GORTLOUGHRA WIND FARM LIMITED

**GORTLOUGHRA WINDFARM,
AN TSEITHE BEAG (SHEHY BEG),
GORTLOUGHRA, CLOGHBOOLA AND
INCHINROE, CO. CORK**

RESPONSE REPORT FOR REQUEST FOR FURTHER INFORMATION (RFI)

RESPONSE TO RFI FROM AN COMISIÚN PLEANÁLA

Figure 1: Annex 1 Condition & Non Annex Habitat Areas

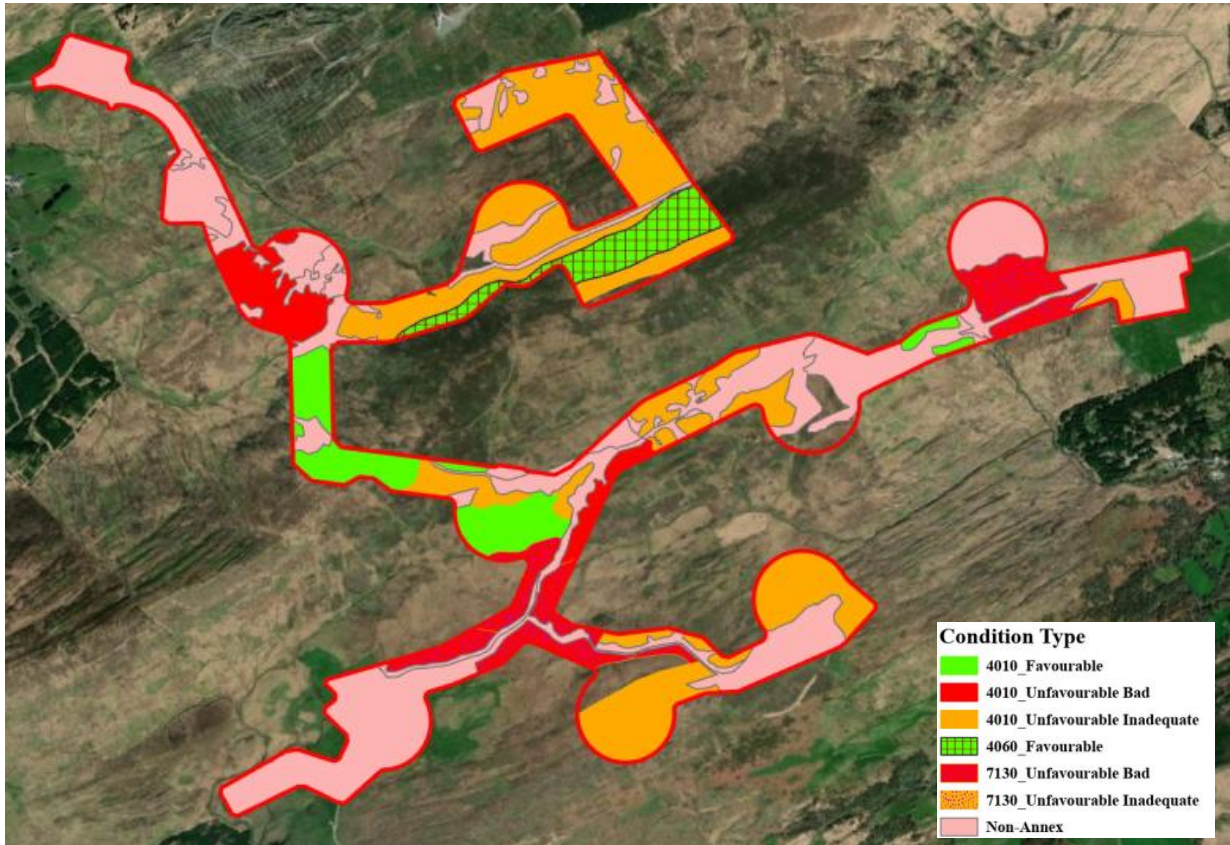
- 9. It is outlined within the Peat and Spoil Management Plan (Management Plan 3 of CEMP) that controlled quantities of peat shall be side-cast adjacent to access roads. Given the location of the existing and proposed internal roads relative to on-site watercourses, you are required to clearly identify the locations where it is proposed to side cast peat and spoil and provide suitable mitigation measures, where necessary, to avoid the siltation of nearby drainage ditches or watercourses.*

9. JOD has prepared Drawing No. 6460-JOD-GLWF-XX-DR-C-0200 to 6460-JOD-GLWF-XX-DR-C-0210 contained in **Appendix 3** which shows the proposed locations for sidecasting of materials and proposed temporary storage areas near turbine locations. These locations have taken into consideration the slopes on site, the locations of watercourses as well as habitats. The temporary spoil areas have been located on areas classified as 'Unfavourable Bad', 'Unfavourable Inadequate' or 'Non Annex' as classified by the project ecologist Doherty Environmental. The constraint hierarchy from least to highest use the following scale from which temporary spoil areas have been identified as shown on **Figure 1** below:

- 1) Non-Annex
- 2) 4010_Unfavourable bad
- 3) 4010_Unfavourable inadequate
- 4) 7130_Unfavourable bad
- 5) 7130_Unfavourable inadequate
- 6) 4010_Favourable
- 7) 4060_Favourable

Figure 1: Location of proposed TDR works in relation to correct location of Wedge Tomb CO093-052002-

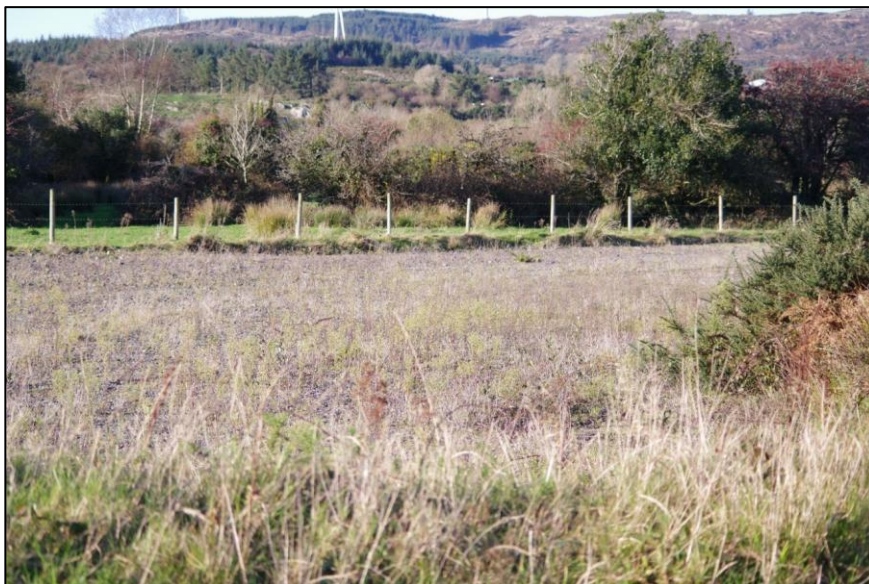
2. *Within Section 13.3.4 (Turbine Delivery Route (TDR) Work Area) of the EIAR, it is noted that a visual inspection of TDR Location 7 from the adjacent roadside did not reveal any extant traces of the wedge tomb (CO093-052002) at the location recorded by the ASI. As noted by the Planning Authority's Archaeologist, the wedge tomb is clearly visible in the same field, c. 88m to the north-east of its marked location and it is clearly visible from the public roadside in many locations. Therefore, the findings of the your assessment should be updated to reflect the actual location of the Wedge Tomb on the ground.”*

2. As noted by the Planning Authority's Archaeologist, the location of wedge tomb CO093-052002- has been incorrectly recorded by the ASI. The location was subject to an archaeological re-inspection in November 2025, and this confirmed the presence of the extant wedge tomb in lands to the north-west of its recorded position (see Figure 1 and photograph below). The proposed TDR works in this area will entail vegetation trimming along the roadside in the south-west corner of the field (c.105m from the correct location of the wedge tomb) and the use of an existing stone-surfaced plot within a separate field to the west as a TDR load bearing area assuming the existing area has not been reinstated prior to construction of the Development (c. 115m west of the correct

location of the wedge tomb) (Figure 1). If it has been reinstated, works will be similar to those that have been carried out i.e. its current condition.

The site inspection confirmed the correct location of wedge tomb CO093-052002- and also confirmed that proposed TDR load bearing area was previously disturbed by the creation of the existing stone-surfaced area. A review of Google Earth imagery indicates that this creation of this stone surface was carried out in 2020. The use of this previously disturbed area and the roadside vegetation trimming works will not extend within 100m of the correct location of wedge tomb CO093-052002- and no direct effects on this archaeological site will occur. The proposed TDR works in this area will result in a temporary, negligible magnitude, indirect, not significant effect on the wider setting of this archaeological site. The correct location of Wedge Tomb CO093-052002- is situated within private lands at a distance of over 100m from proposed TDR works in this area. Given the disturbed nature of the proposed TDR load-bearing area combined with the distance of the correct location of Wedge Tomb CO093-052002- from the TDR works, no protective mitigation measures, such as the erection of protective fencing around the site, are considered to be required.

Figure 2: (Figure 2.1 of the EIAR): Wind Farms within 20km of the proposed Development

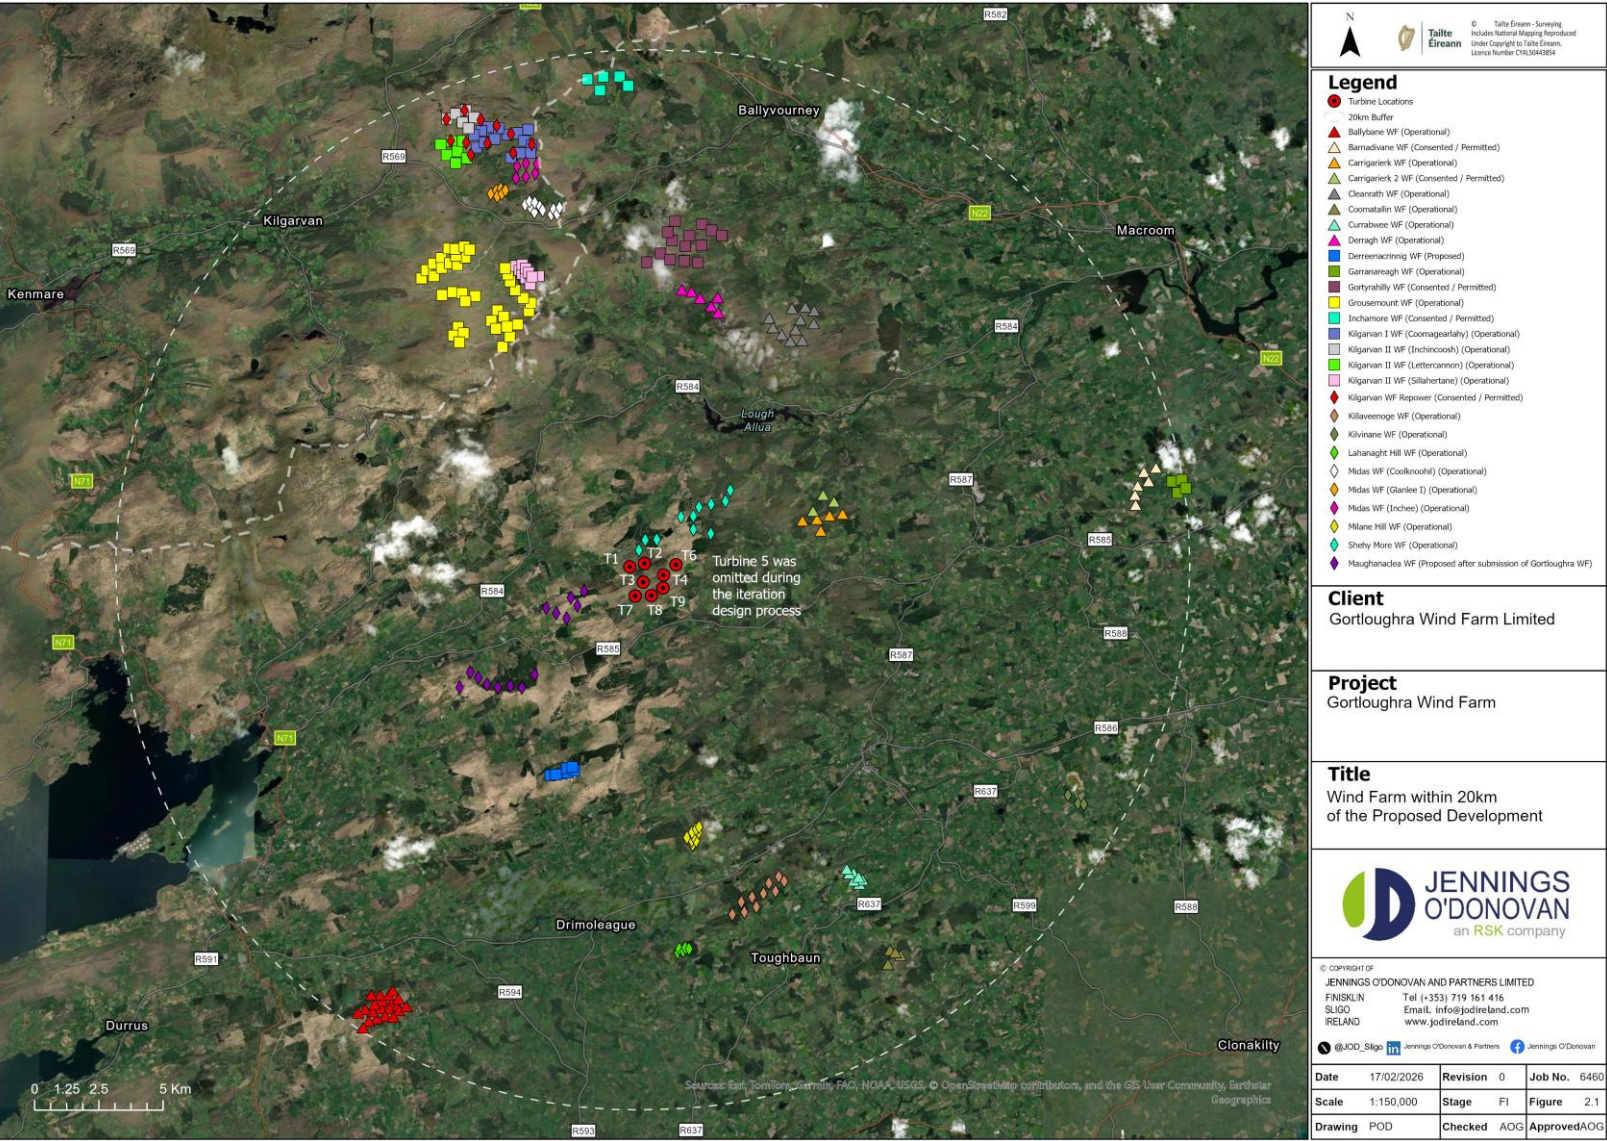
1. *"As per Section 2.5.2 (Wind Farms in the Area (Cumulative)) of the EIAR it is noted that there are 28 no. operational, permitted and proposed wind farms within 20km of the site. However, only 24 wind farms have been identified in the corresponding table (Table 2.1). In addition, Chapter 11 (Landscape and Visual) notes that there are 18 no. operational, 4 no. consented and 3 proposed wind farms (25 in total) within the 20km study area. You are required to clarify these discrepancies and ensure consistency throughout the entirety of the EIAR.*

The cumulative wind farm locations, together with their status, turbine numbers, and distances from the Proposed Development, are illustrated on the updated **Figure 2.1** in **Appendix 5**. The cumulative baseline presented in **Chapter 2** of the EIAR (**Table 2.1**) has been updated to reflect the revised dataset provided in **Table 2** below.

Figure 3: (Figure 1.3 of the EIAR): 73 no. Receptors within Shadow Flicker Study Area radius

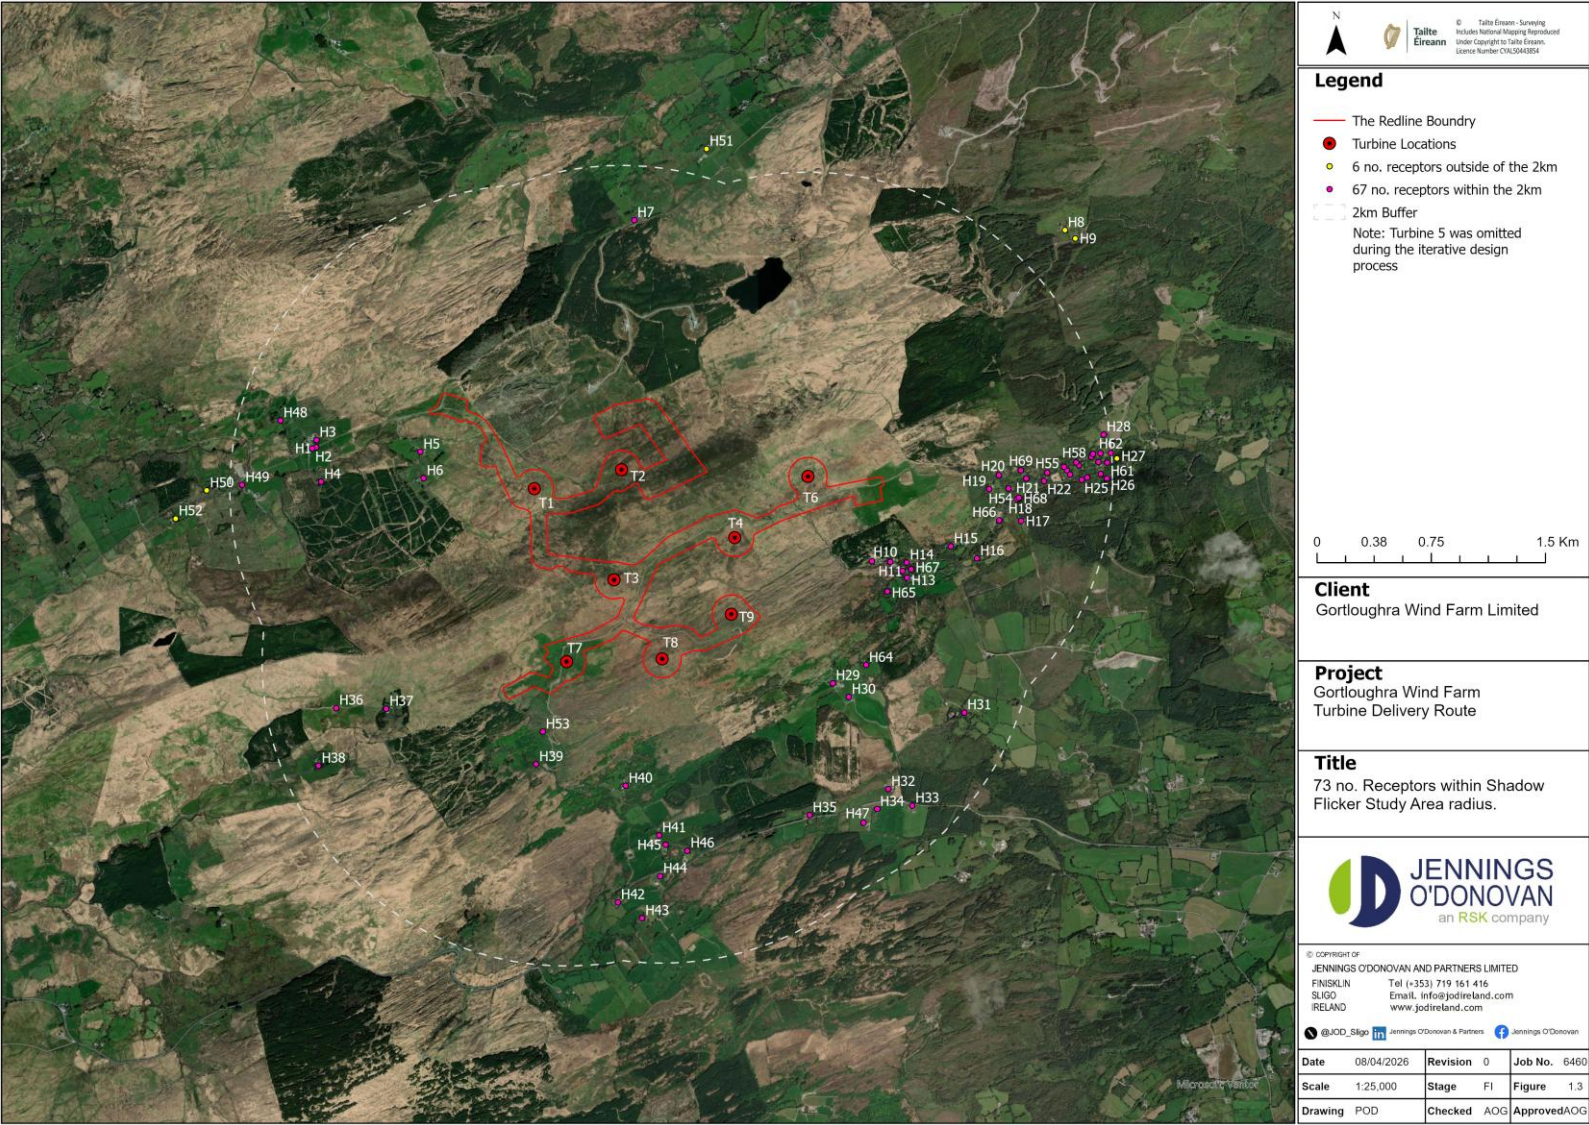
2. *A total of 73 no. receptors have been identified in Chapter 10 (Noise) of the EIAR. Chapter 16 (Shadow Flicker) of the EIAR has also identified 73 no. receptors within the shadow flicker Study Area radius. The coordinates of each sensitive receptor and its distance to the closest proposed turbine are listed in Table 16.2 of the EIAR. However, this table identifies a total of 87 no. receptors. Furthermore, up to 83 no. receptors are identified in Figure 1.3 (Receptors within 2km of the Proposed Turbines) of the EIAR. However, there are a number of receptors in this Figure that appear to be omitted and include H16, H24, H25, H32, H43, H51, H52, H53, H54, H55, H56, H57, H58, H59, H63, H64, H66, H73, H74, H75, H79 and H81. You are required to therefore clarify these discrepancies and submit a revised receptor map which clearly identifies the location of each receptor within the identified study area. You are required to ensure that there is consistency throughout the EIAR in terms of the identification of receptors.*

2. **Figure 1.3** of the EIAR which identified all the receptors within a 2km buffer has been updated. This is to be consistent with the list used in the Noise assessment. There are a total of 67 no. receptors within 2km of the proposed turbines. A further 6 receptors are slightly outside the 2km threshold but were added for completeness due to their proximity to the boundary used. Therefore, the receptor list used shows 73 no. receptors. The updated **Figure 1.3** is included in **Appendix 5** (reproduced below for ease of reference). The Shadow Flicker assessment has been updated to be consistent with this list (including **Table 16.2**) and can be found in **Appendix 4** and the detailed results (Appendix 16.1 of the EIAR) can be found in **Appendix 6**.
